Projec	t Nam	е	East Mud Lakes	Neir B	ox Replacement	
Projec	t No.	11362	Task No.	01	Addendum No. 1	
То:	Prospe	ctive Bid	ders		Date:	2/8/2024

The following items are clarifications to the bid documents. These items are hereby included in the bid documents by this addendum.

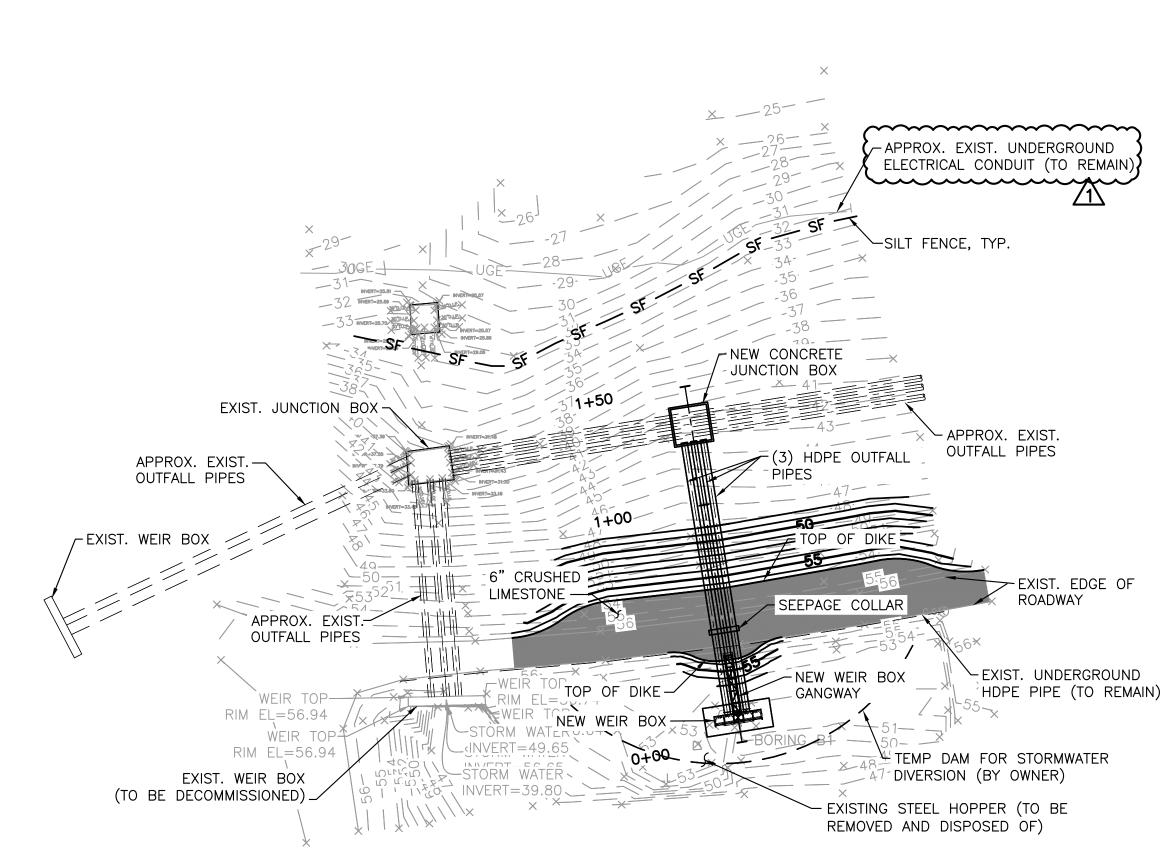
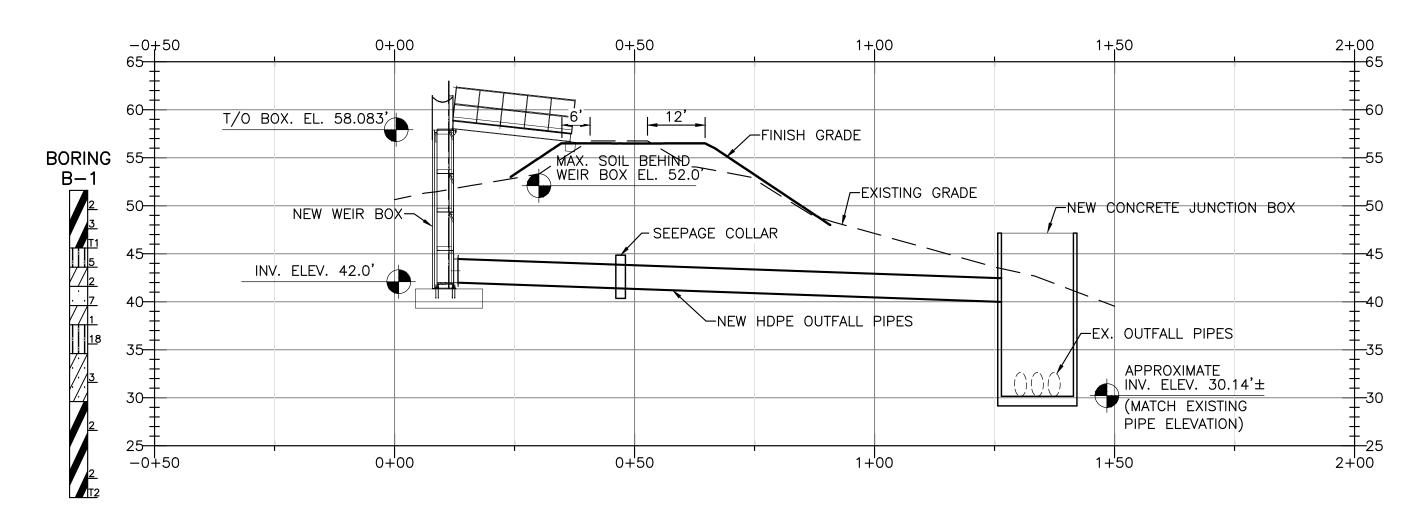
3.	Clarification: Grating type. Sheet G002 Note 8.3 calls for McNichols GW 125, 19-W-4 Serrated. Sheet S100 Note 10 calls for 2"x2"x2" Corvex FRP 7 and Weir Box Plan calls for 1". Answer: See revised drawing G002 and S100 for clarification.

RAMP: GRATING SHALL BE 1"x3/16" STEEL GRATING SPACED 1 3/16" O.C. TYPE WB AS MANUFACTURED BY IKG BORDEN. GRATING TO BE MANUFACTURED IN FULLY BANDED PIECES NOT-TO-EXCEED 150 LBS. IN TOTAL WEIGHT. WEIR: GRATING SHALL BE 2"x2"x2" CORVEX FRP GRATING IN 4-FT BY 4-FT PANELS
